**TOWN OF SCITUATE**  
*Design Review Committee*

**Meeting Minutes for: Wednesday, March 21, 2018**

**DRC Review of 7-9 Marshfield Ave. Design Concepts for Proposed New Deck**

*Example of acceptable exterior lighting sconce, from Cocoweb.com:*

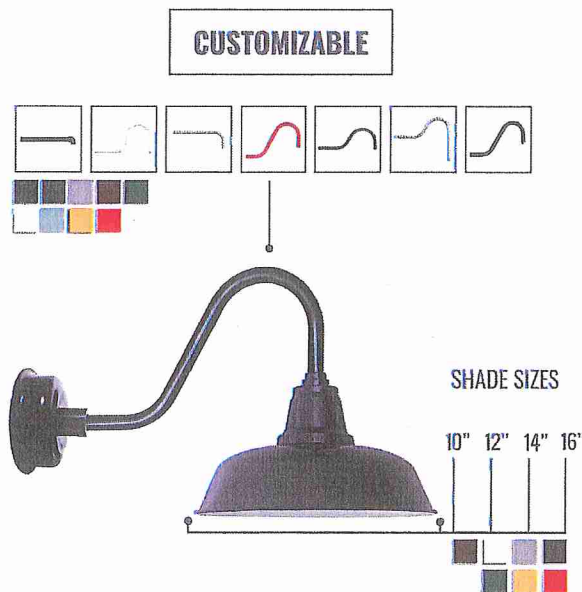
**Lighting:** The DRC recommends requiring both string lighting as well as a wall-mounted industrial-style gooseneck sconce (or a pair of sconces) to provide lighting. The decorative appearance of string lighting that can be strung from the high poles of the planters will provide a warm, human-scale counterbalance to the industrial-scape, and the gooseneck industrial lights will pay reference to the warehouse style building, yet will provide a contrast to the horribly-utilitarian, exterior-mounted fixtures that are currently mounted high up on the exterior walls of the bulk of the building. These fixtures should be lamped with warm color-temperature bulbs, instead of mercury- or neon-colored bulbs. The DRC suggested that a similar gooseneck sconce should be mounted outside the main central door beneath the staircases in order to unify the look.
